# West Coast Bays Marine Park - PART A

Zoning Advice from MPLAG Meeting 4 - 22/2/2011

**Marine Park: West Coast Bays PART A**

**Date of meeting: 22/02/2011**

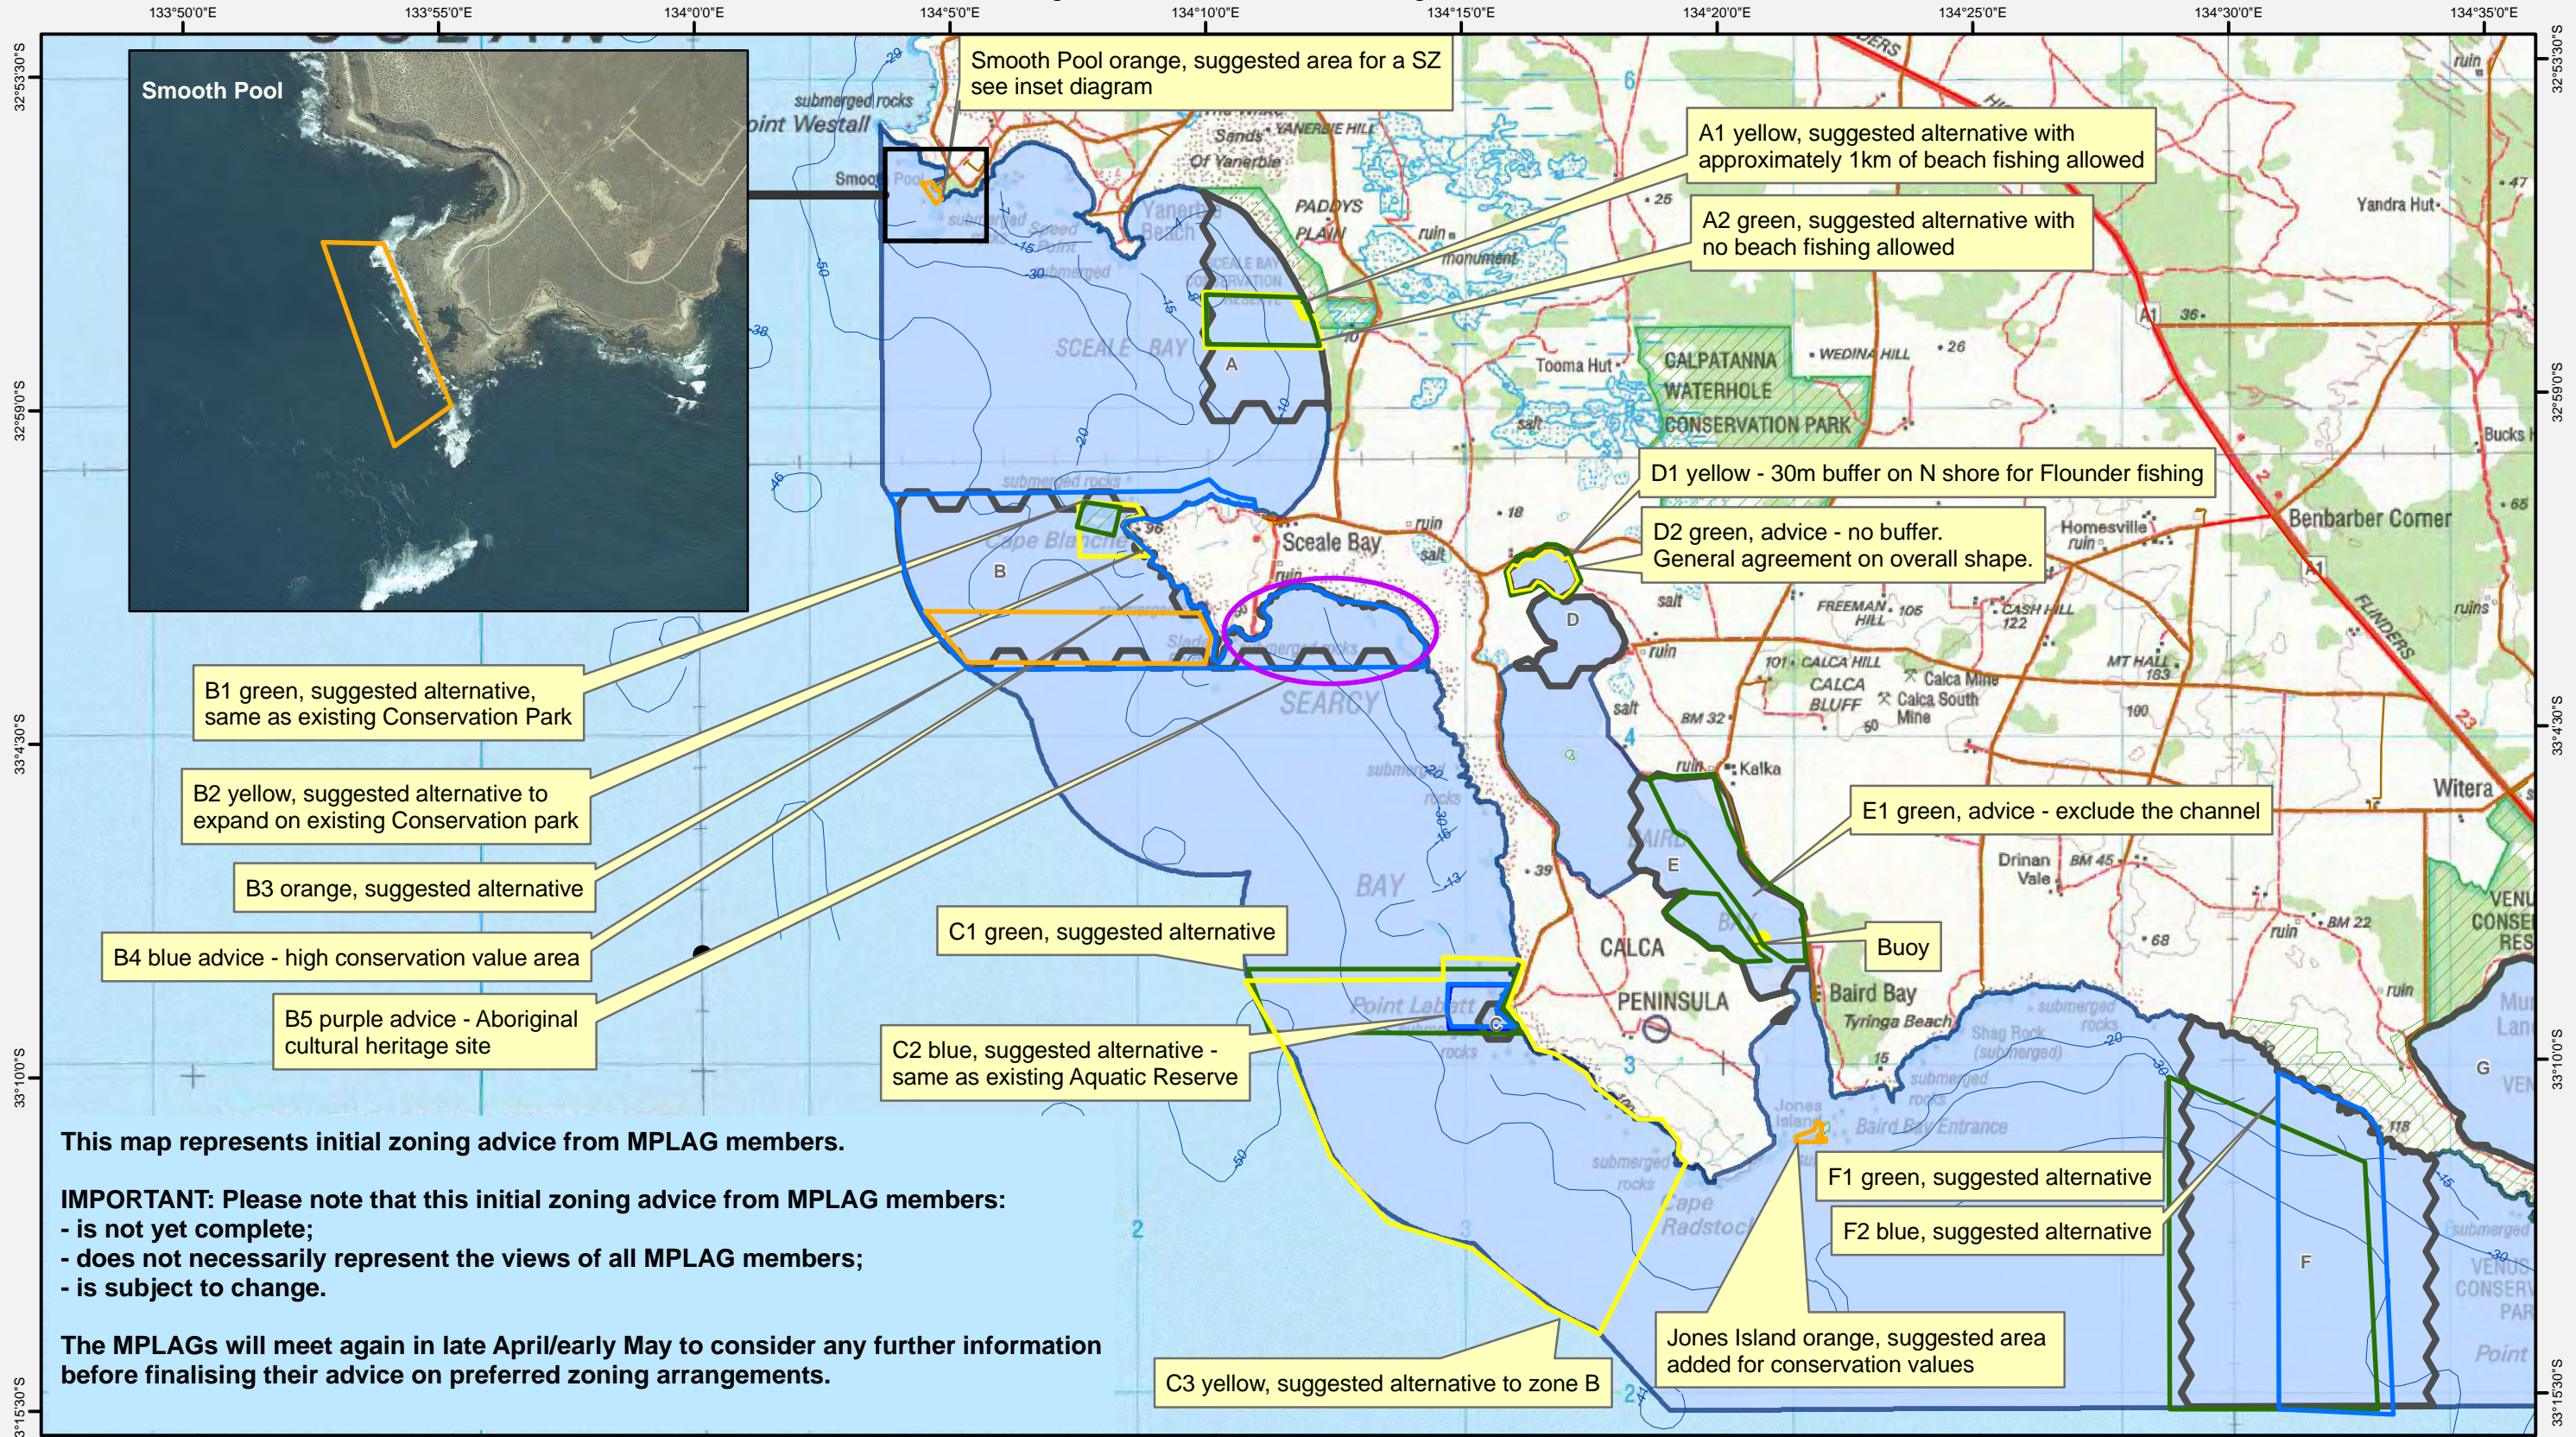
Smooth Pool orange, suggested area for a SZ see inset diagram

A1 yellow, suggested alternative with approximately 1km of beach fishing allowed

A2 green, suggested alternative with no beach fishing allowed

D1 yellow - 30m buffer on N shore for Flounder fishing

D2 green, advice - no buffer. General agreement on overall shape.

B1 green, suggested alternative, same as existing Conservation Park

B2 yellow, suggested alternative to expand on existing Conservation park

B3 orange, suggested alternative

B4 blue advice - high conservation value area

B5 purple advice - Aboriginal cultural heritage site

C1 green, suggested alternative

C2 blue, suggested alternative - same as existing Aquatic Reserve

E1 green, advice - exclude the channel

F1 green, suggested alternative

F2 blue, suggested alternative

C3 yellow, suggested alternative to zone B

Jones Island orange, suggested area added for conservation values

<b>Zone</b>	<b>Comment number (or colour)</b>	<b>Comment</b>
A	A1 (yellow)	Alternative to original sanctuary zone with a shoreline buffer of approximately 1 km for beach fishing access (majority support).
A	A2 (green)	Same dimensions as alternative 1, but without a shoreline buffer. Both suggestions for zone A have potential impacts for cray and recreational fishing.
Smooth Pool	Smooth Pool (orange)	Possible sanctuary zone for an area of high conservation value. Community opposition – potential impact on abalone, recreational fishing and tourism.
B	B1 (green)	Keep existing Nicolas Baudin Island Conservation Park as is; relocate the bulk of this zone to Point Labatt.
B	B2 (yellow)	Expand for extra protection of Nicolas Baudin island – also include cliff shoreline. Avoid high level recreational fishing further south.
B	B3 (orange)	Suggested alternative to B.
B	B4 (blue)	High value conservation area. Multiple environmental benefits (though potential for negative impacts to commercial and recreational fishing as well as tourism.(Not majority support)

B	B5 (purple)	Aboriginal cultural heritage site
B	Comment	Slade Point and eastwards is a high access shoreline
C	C1 (green)	Extend out to the edge of State waters

<b>Zone</b>	<b>Comment number (or colour)</b>	<b>Comment</b>
C	C2 (blue)	Maintain existing aquatic reserve
C	C3 (yellow)	An alternative to Cape Blanche (potentially high impacts on all commercial fisheries). Not majority support.
D	D1 (yellow)	Move southern boundary further north. Include a 30m shoreline buffer for flounder access on northern shoreline.
D	D2 (green)	Same as advice D1, except remove the shoreline buffer – it is a unique beach type. Recreational flounder opportunities exist elsewhere in the bay.
E	E1 (green)	Sanctuary zone which excludes the channel area. Majority support.
Jones Island	Jones Island (orange)	Suggestion to add the SW corner of Jones Island for conservation values. Not majority support.
F	F1 (green)	Bring the sanctuary zone's northern boundary out to follow the 25m depth contour. Majority support.
F	F2 (blue)	If cliff shoreline is to be included in this sanctuary zone, then this design would lessen the impact.
